Groundwater Application Review Summary Form

Application # G- 18595

To: Kristopher Byrd, Well Construction and Compliance Section Manager
From: Joel Jeffery, Well Construction Program Coordinator
Subject: Review of Water Right Application G-18595
Date: August 31, 2018

TO: Water Rights Section Date 08/30/2018
 FROM: Groundwater Section Darrick E. Boschmann
 Reviewer's Name
 SUBJECT: Application G-18595 Supersedes review of N.A.
 Date of Review(s)

Theis Time-Drawdown Worksheet v.3.00

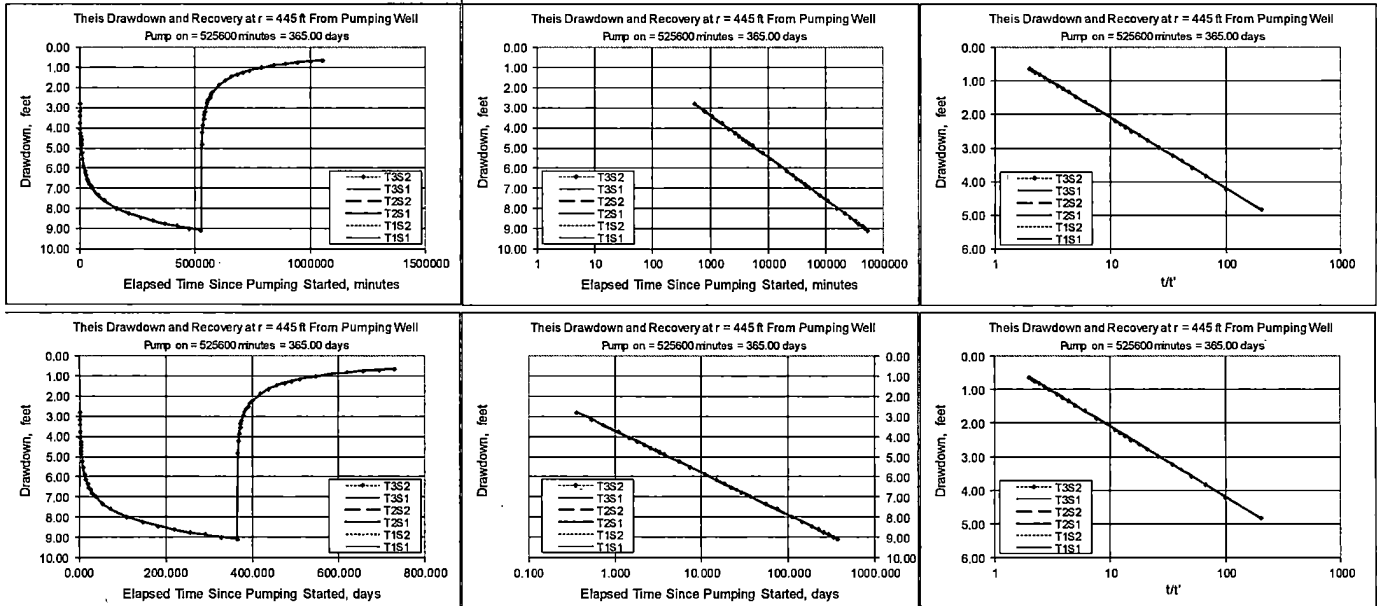
Proposed production well LAKE 52530 is located ~445 feet north of POD 1 under transfer T-11894 (LAKE 1627 "Hot Well"). LAKE 1627 (reconditioning log LAKE 4448) has a reported water temperature of 212 degrees F. The potential increase in interference at LAKE 1627 was calculated using the Theis equation (see attachment). The values for the calculation are conservative and appropriate until better values become available. The calculations use an intermediate storage coefficient (0.001). The transmissivity used in the calculation (5,050 ft²/day [1ft²/day ≈0.37 darcy-ft]) is the transmissivity of the deep geothermal aquifer derived from the Geologica multi-well interference test (report dated 04/19/2018). At the maximum proposed pumping rate for LAKE 52530 (0.67 cfs), the results show an increase in drawdown of ~9 feet after 365* days, which should be within the capacity of the well.

*Note: interference will continue to increase after the 365 day calculated value for this proposed year-round use.

LL-1727 to Chewaucan River

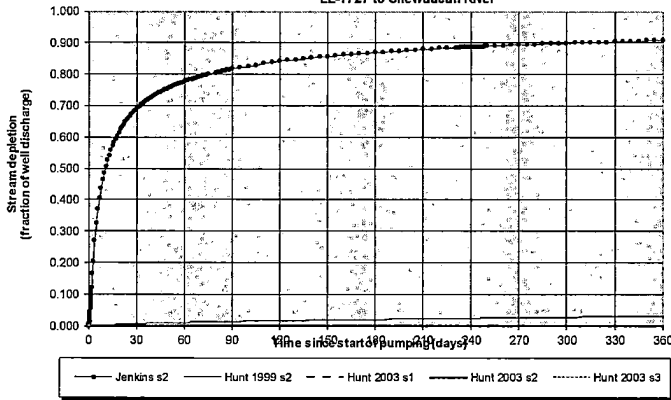
Hunt (2003) was used to calculate the interference between Well 2 and SW #1; the closest well outside of a mile from hydraulically connected surface water. The values used for the calculation are conservative and appropriate until better values become available. The calculations use an intermediate storage coefficient (0.001). The transmissivity used in the calculation (5,050 ft²/day [1ft²/day ≈0.37 darcy-ft]) is the transmissivity of the deep geothermal aquifer derived from the Geologica multi-well interference test (report dated 04/19/2018).

Interference is calculated to be less than 1% of the natural flow at 80% exceedance for all months evaluated.
